Item #7:
Village President Rodriguez
B. IL Route 22 Widening – West Of IL 83

~ Draft ~
**IDOT/VILLAGE OF LONG GROVE
COORDINATION MEETING MINUTES
Tuesday, May 4, 2010
Village of Long Grove, Village Hall**

**Illinois Route 22
Quentin Road to Illinois Route 83
P-91-284-00**

Impact Attenuator at End of Retaining Wall

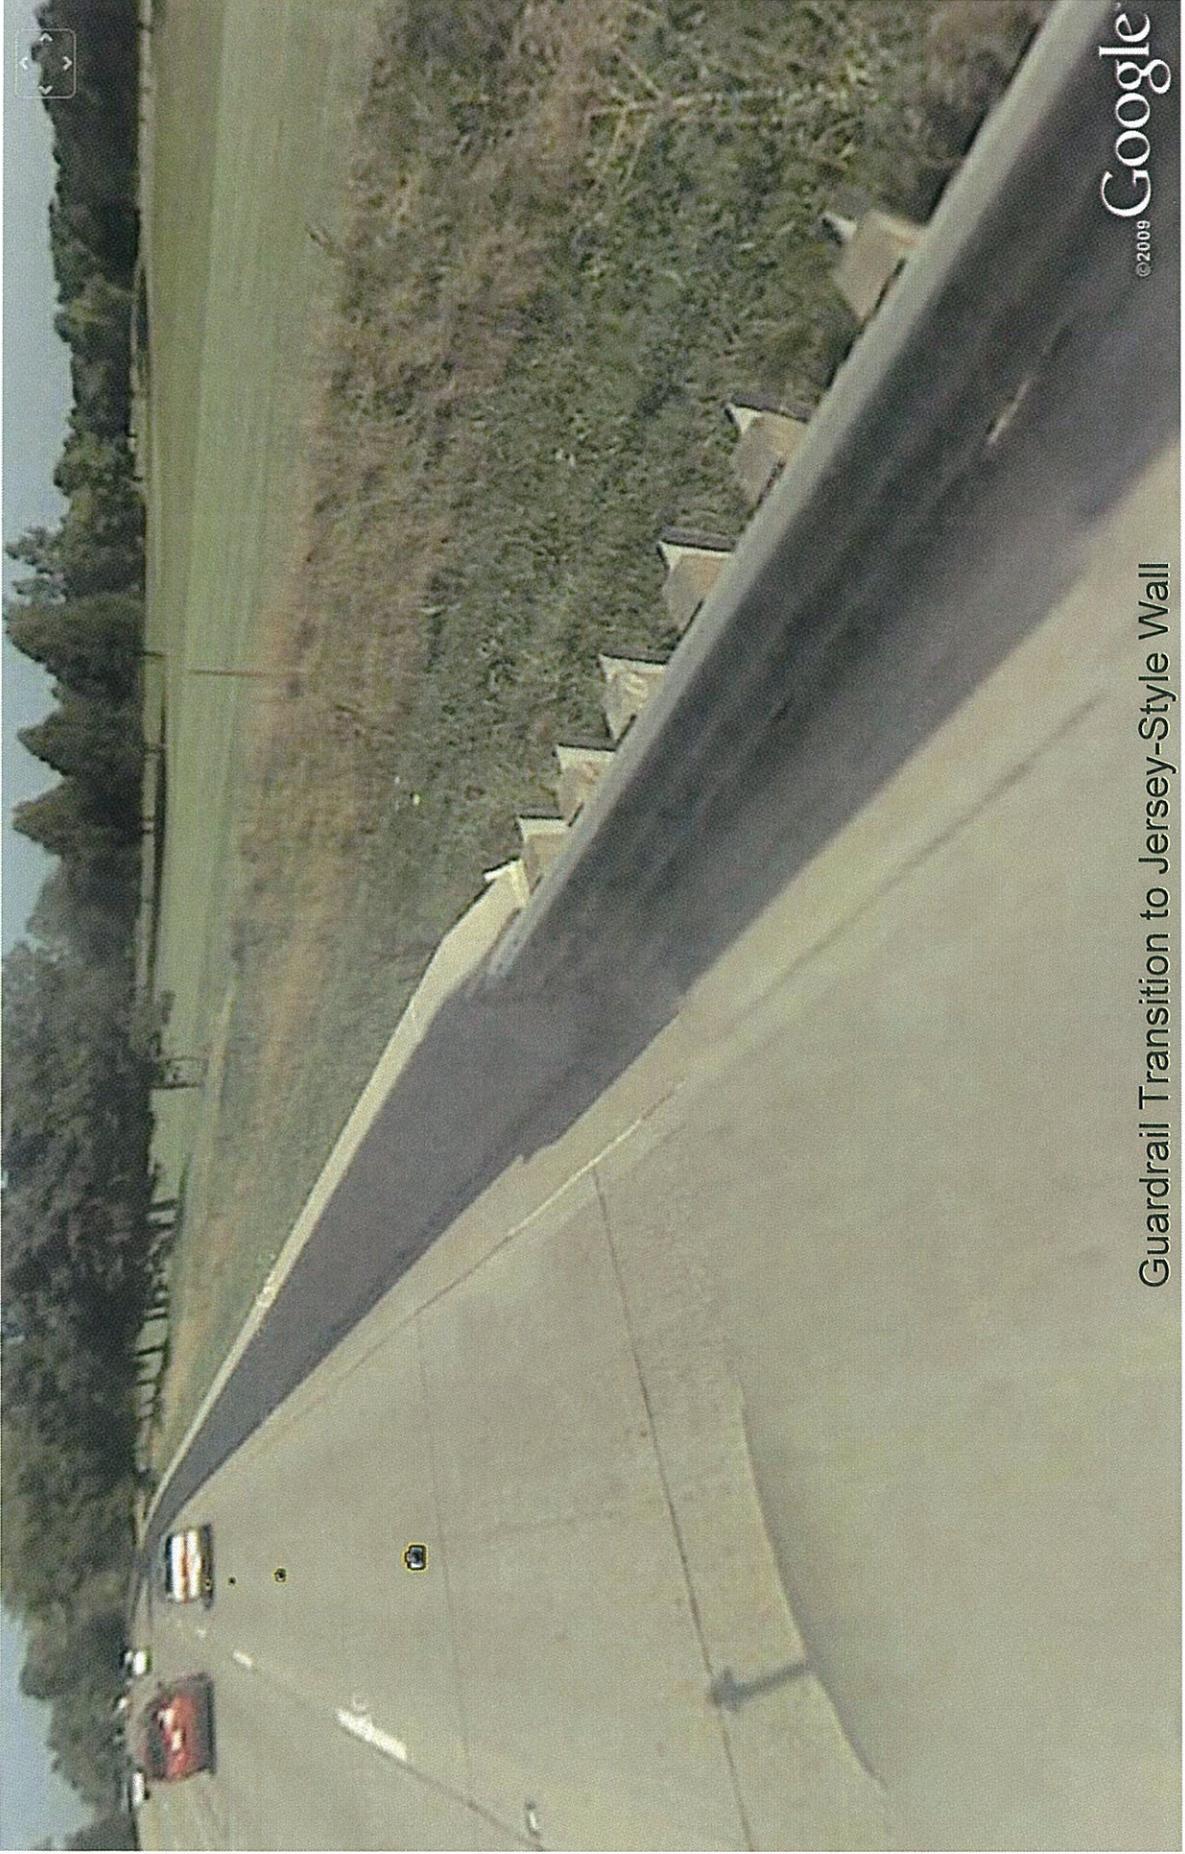
- **Wall #15, Sta. 120+00, RT - SHORTENED** – This fill-section wall was shortened on the east end by allowing some drainage to the roadway over the back of curb since the roadway profile is in a crest section. The remainder of the wall must be kept to avoid encroachment into the SCE. Even with the wall, PE and TE will be required in the SCE at the Oak Creek Lane to allow for a tapered wall for sight distance. Aside from the sight distance taper, this wall will be constructed at the back of the 2-foot concrete gutter along the south edge of pavement. To provide for necessary drainage swales and utilities replacement, it will be a Jersey-style concrete barrier wall, similar to what is constructed on IL Route 22 east of IL Route 21 in Lincolnshire. It will require end protection in the form of impact attenuators or guardrail extending from both ends. See attached photos.

Village Option: This entire wall can be eliminated if the Village allows a PE in the SCE. The PE would be required to establish a drainage swale to gather both runoff from private property toward the roadway (in most sections) and runoff from the roadway embankment behind the back of curb (in all sections). IDOT will discuss with its hydraulics and right-of-way staff the potential for the swale to be Village-maintained, which might eliminate the need for the PE. It was noted that there would be minimal tree loss within this potential PE as there are few trees behind the proposed edge of pavement between Oak Creek Lane and Sta. 124+00. IDOT also noted that if the Village were to allow an additional temporary use area within the SCE, this would be a prime location to plant replacement trees.

Modular Block Wall

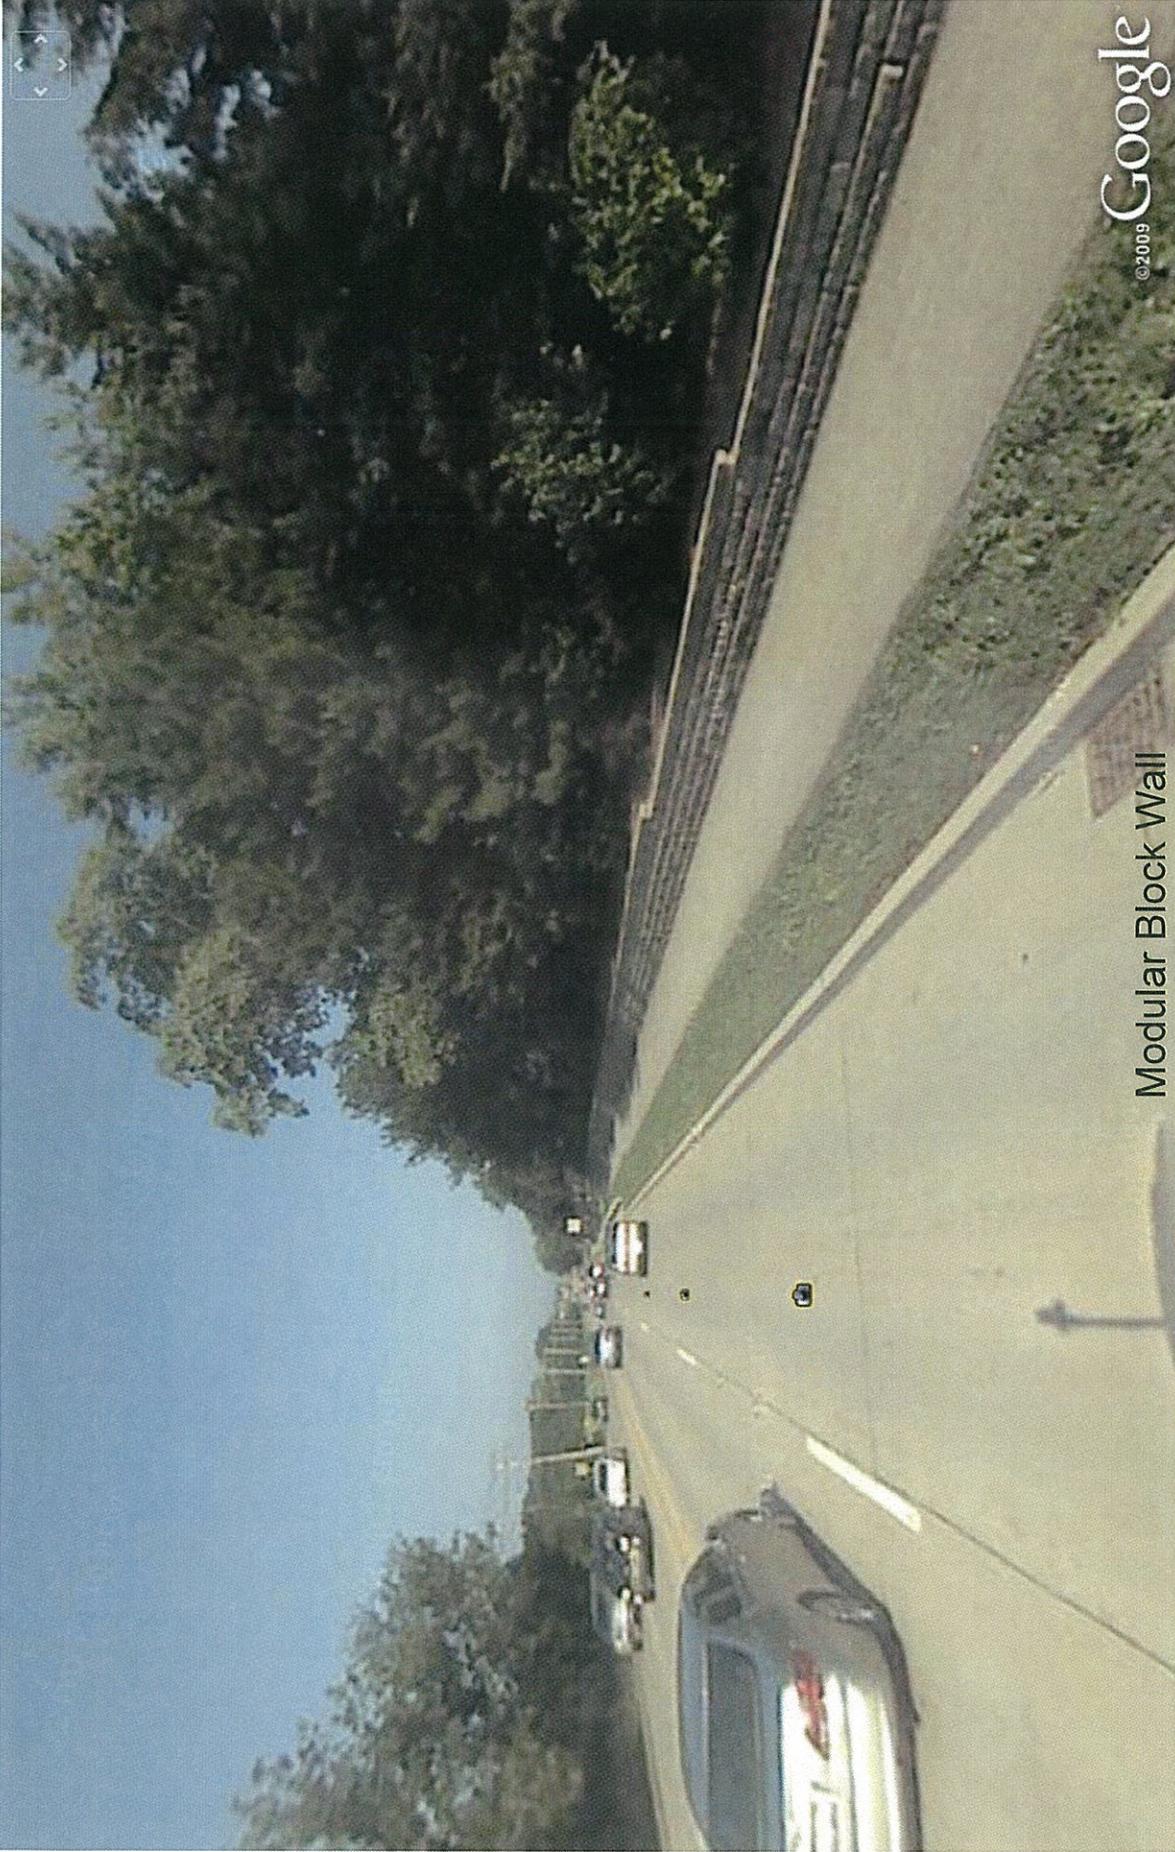
The Village re-stated a concern about the aesthetic character of the walls. The Village requested that the walls be both durable and low-maintenance, and asked if modular block walls could be used. IDOT responded that those are acceptable when the wall is retaining the adjacent ground, i.e., in cut-sections where the adjacent ground is higher than the roadway.

This type of wall is also only feasible when the wall is set a sufficient distance from the roadway. There is a height limitation for the installation of this type of wall. The Village prefers decorative walls to plain concrete where possible. A photo of a block wall installation on IL Route 22 to the east was shown, and is attached.
